MONITORING YEAR 5 ANNUAL REPORT

HENRY FORK MITIGATION SITE

RE: **Response to MY5 Draft Report Comments**
Henry Fork Mitigation Project
DMS Project # 96306
Contract Number 005782
RFP Number 16-005298
Catawba River Basin – CU# 03050103 Expanded Service Area
Catawba County, North Carolina

Monitoring Year 5 - 2020

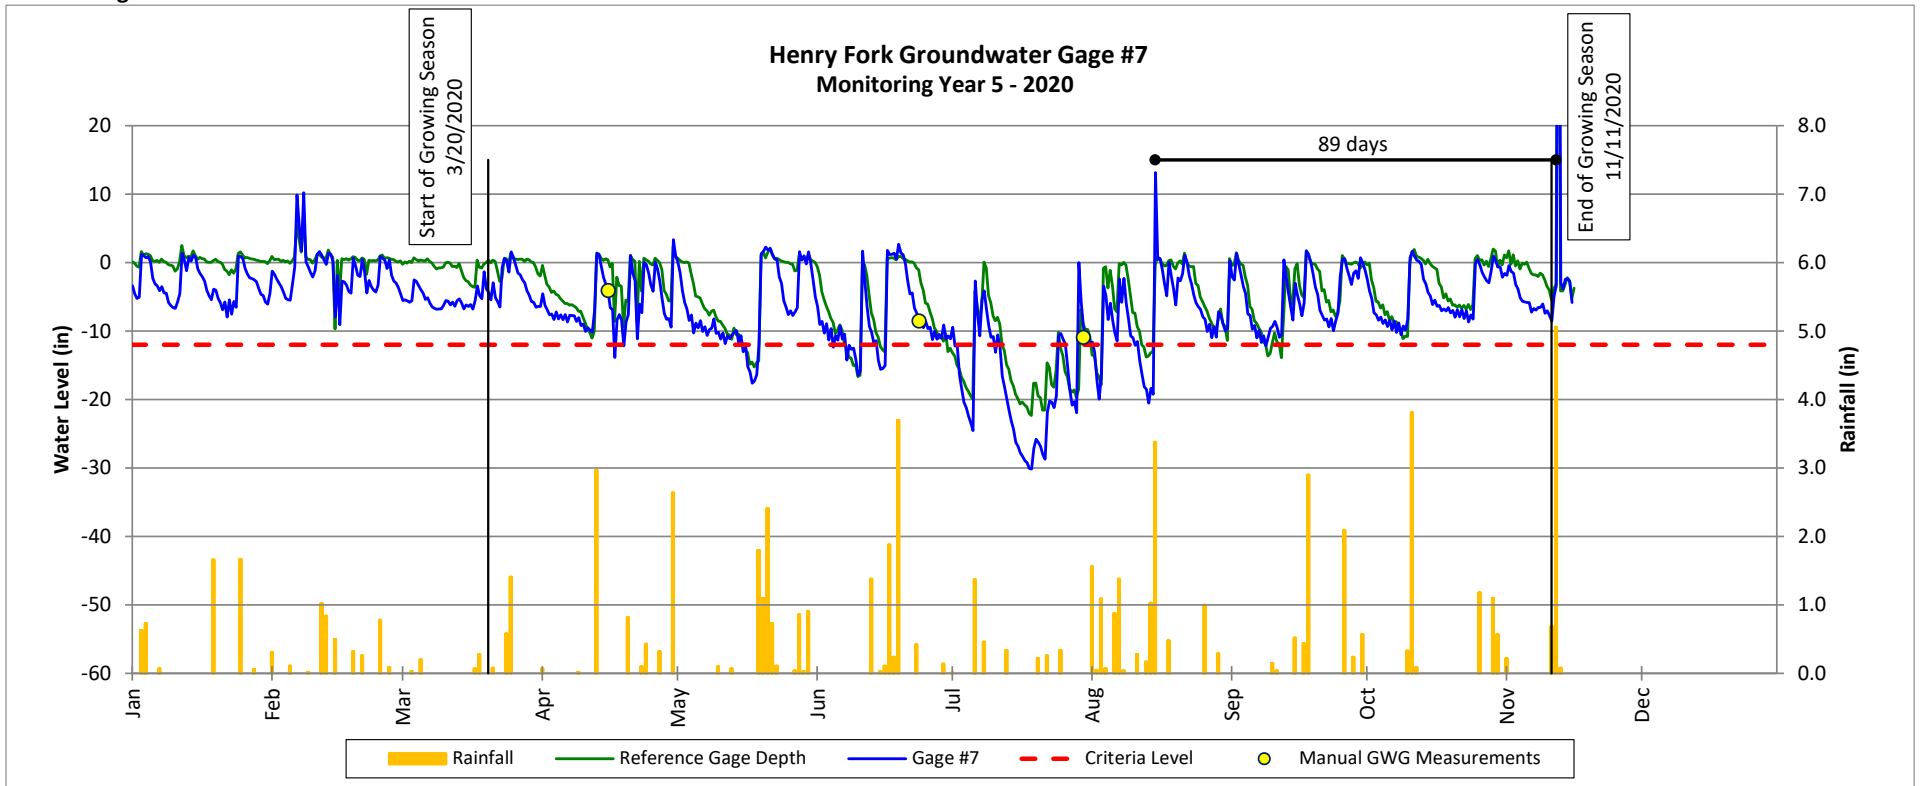
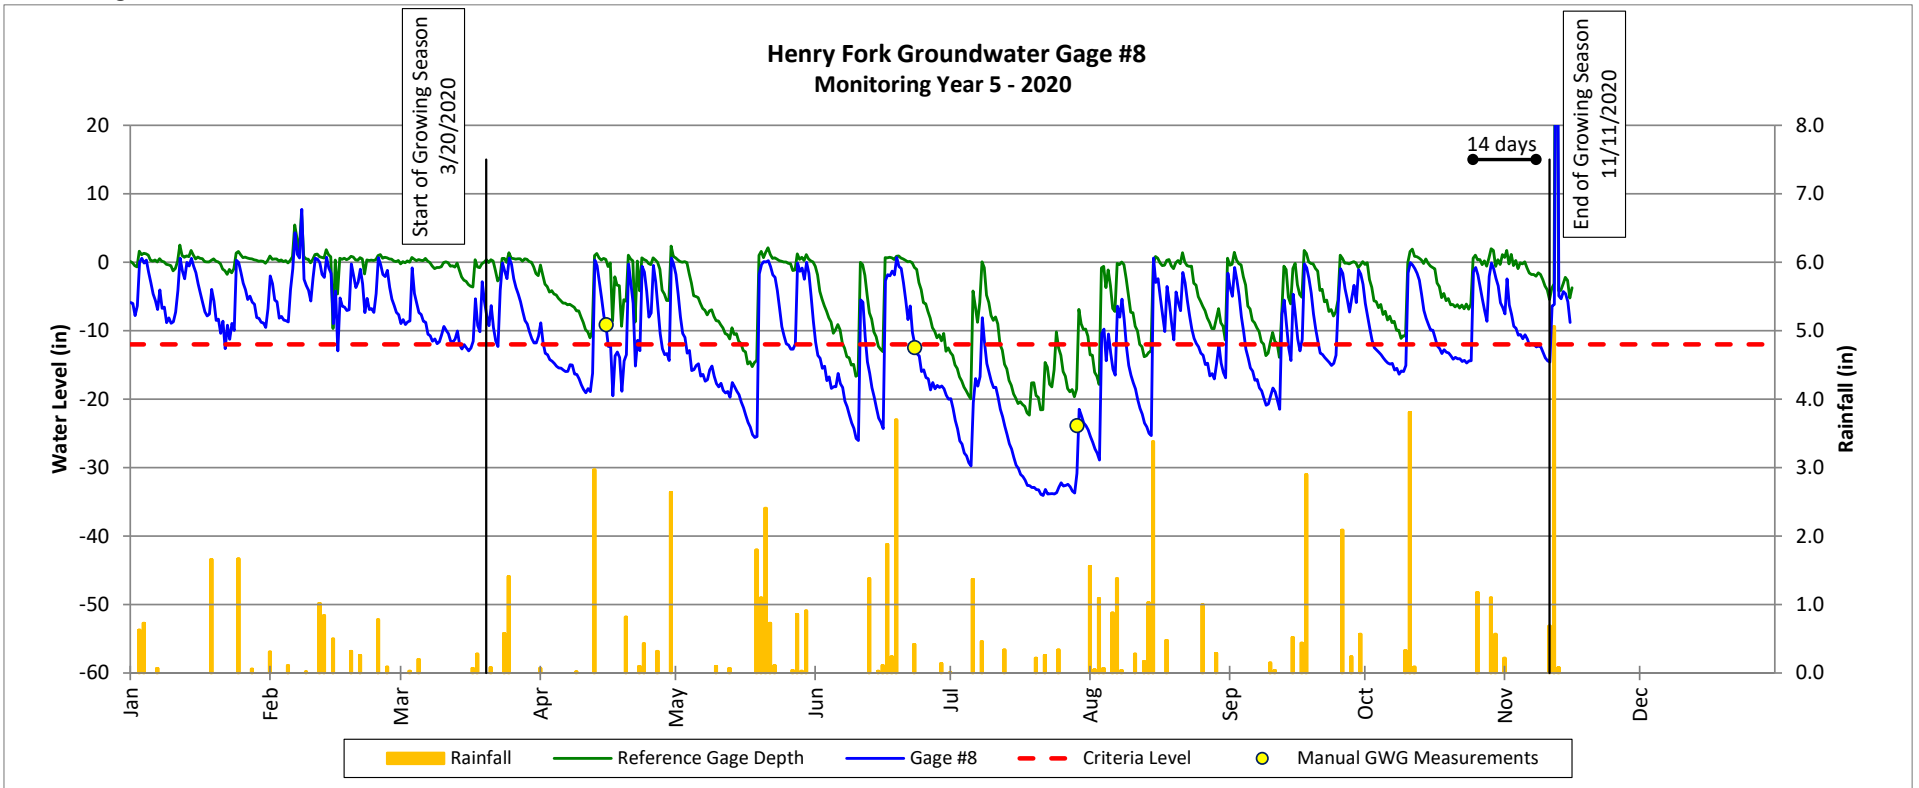
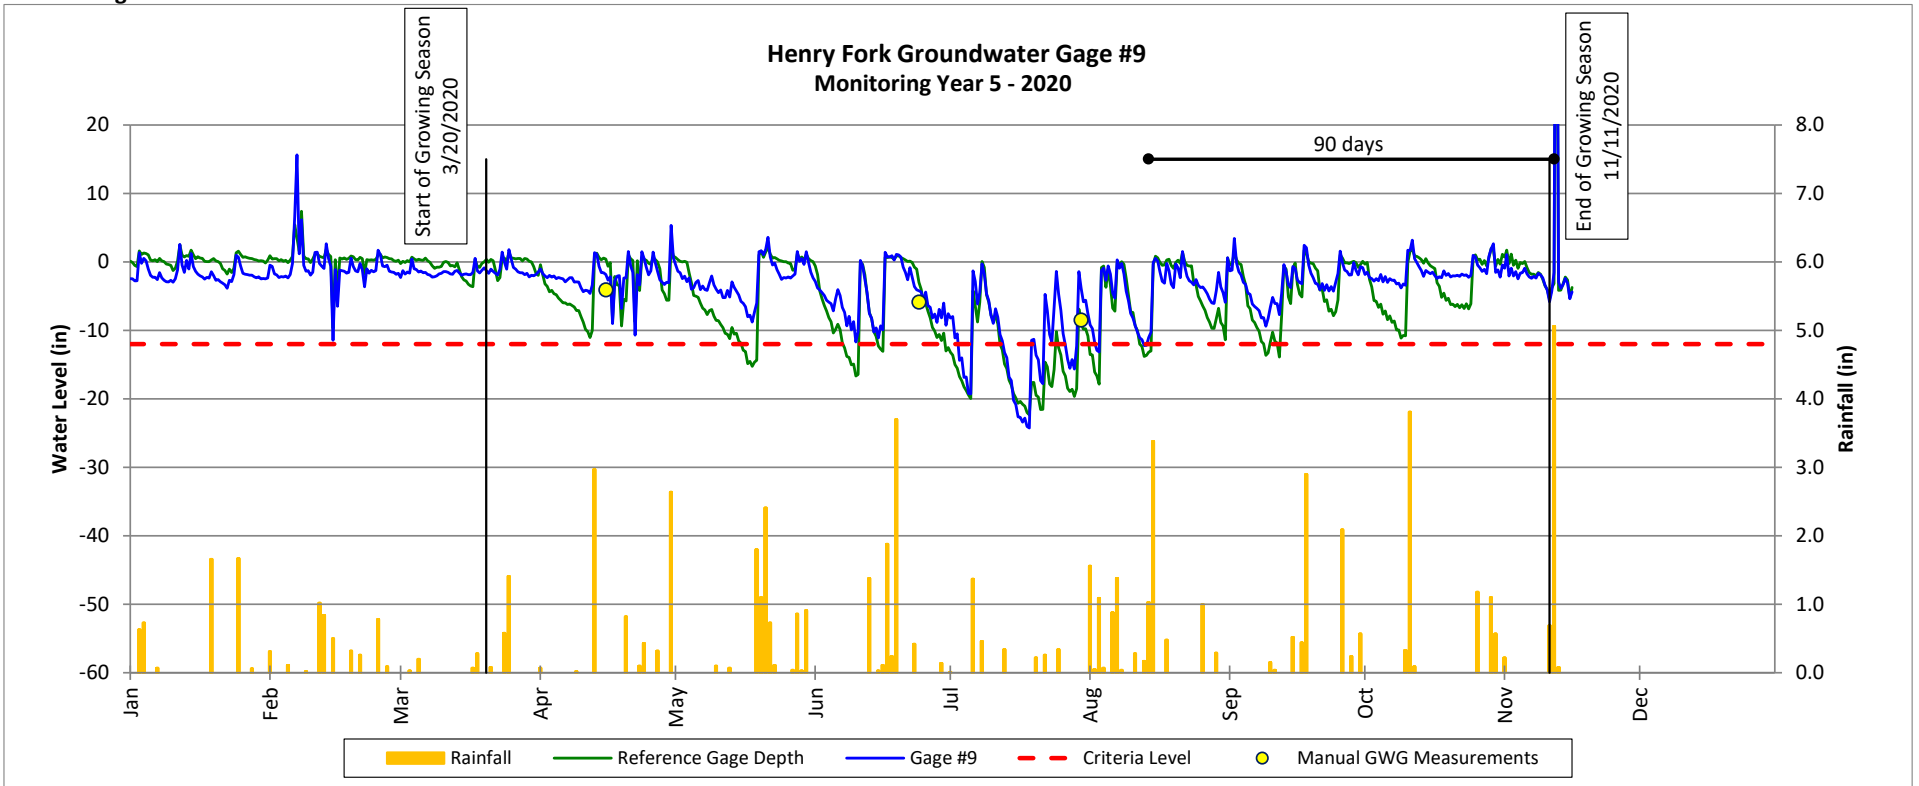
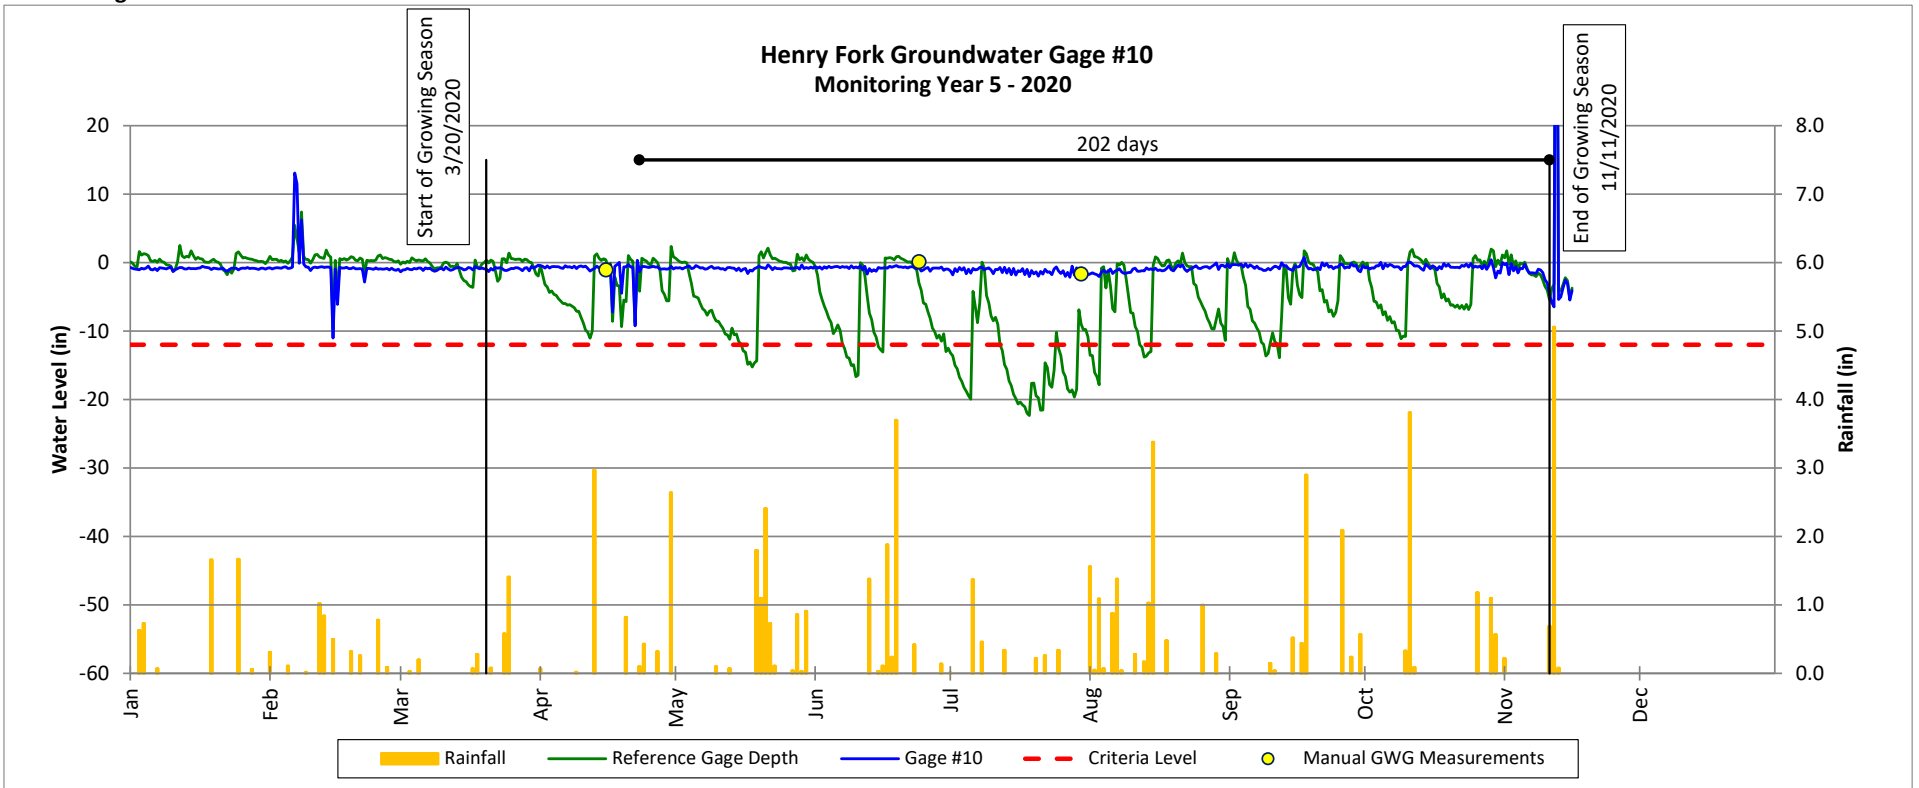
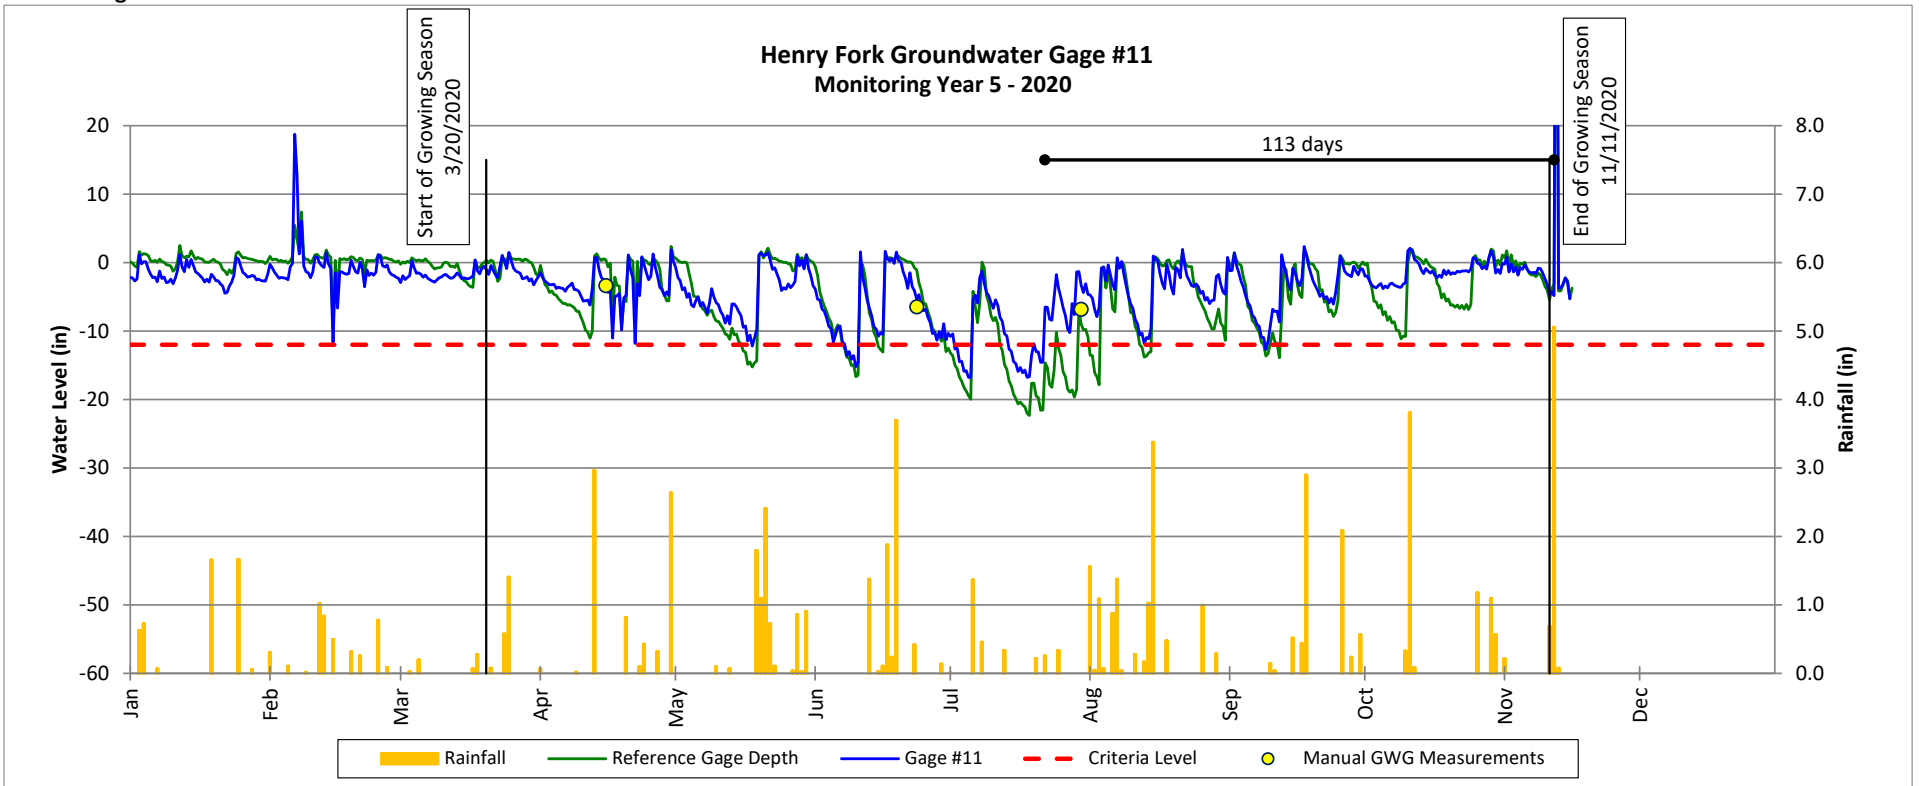
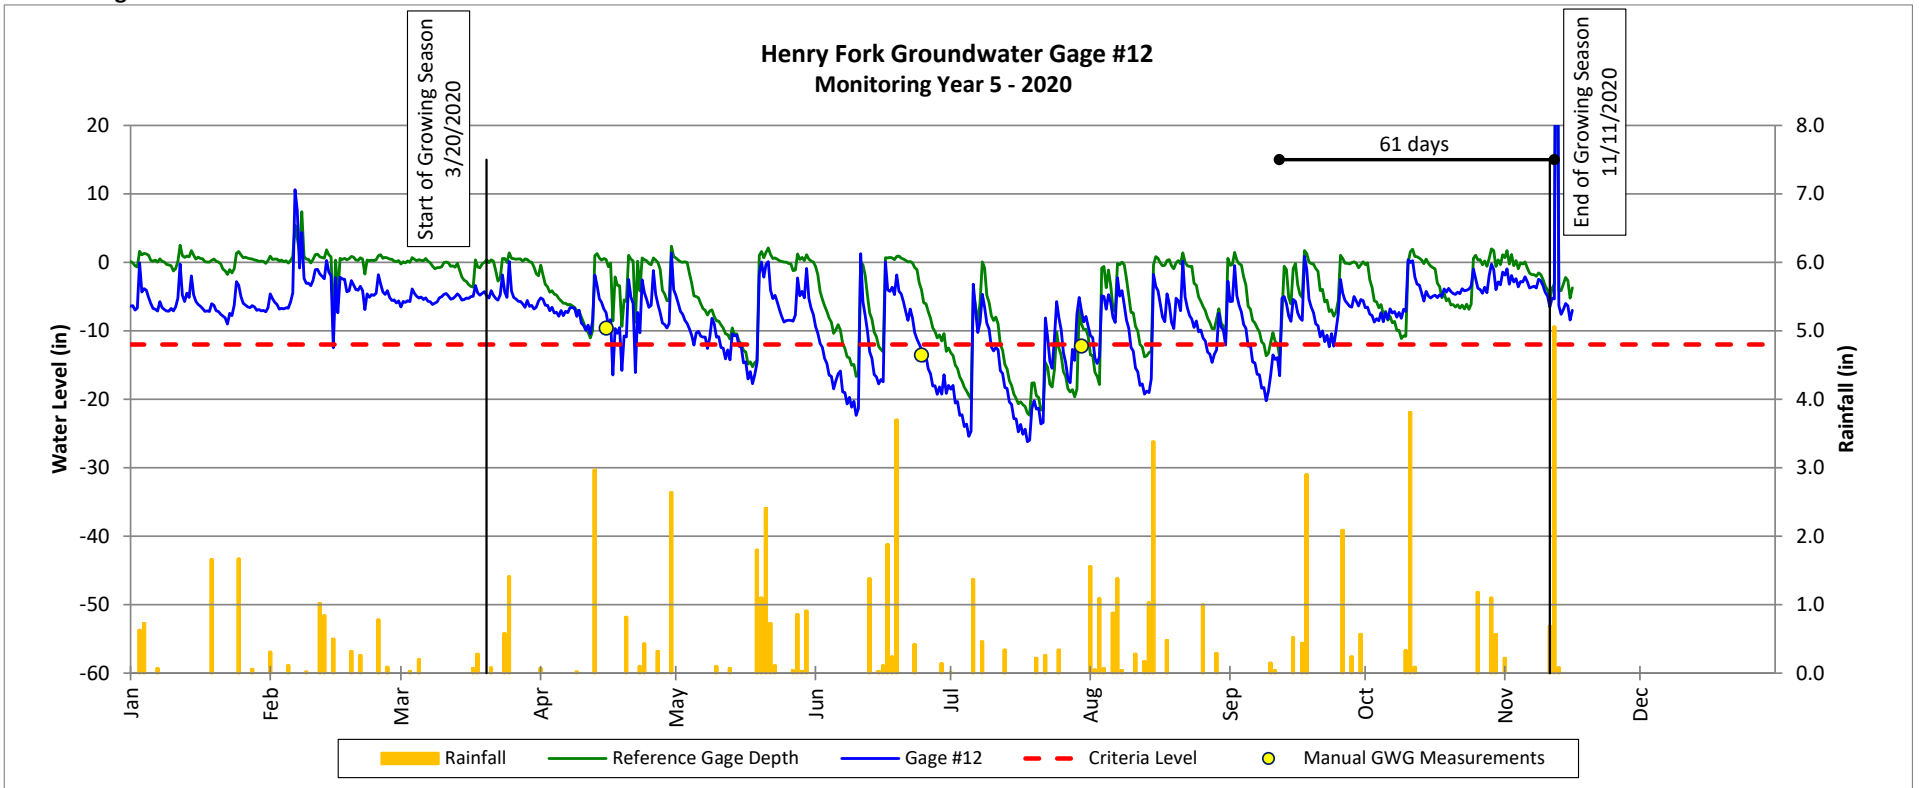
DMS comment: Groundwater Gage Plots: The note at the bottom of the graphs regarding the barotroll malfunction is unclear. It says the data collected during the February and April 16-17 malfunctions were omitted, but then then says the readings conducted during April 16-22 was verified and included. Is the April 16 date in the verified statement supposed to be April 21? Please review and revise as necessary.

Wildlands response: The note at the bottom of the groundwater gage plots has been revised and simplified to indicate that the data collected during the February and April malfunctions was omitted from the reported data.
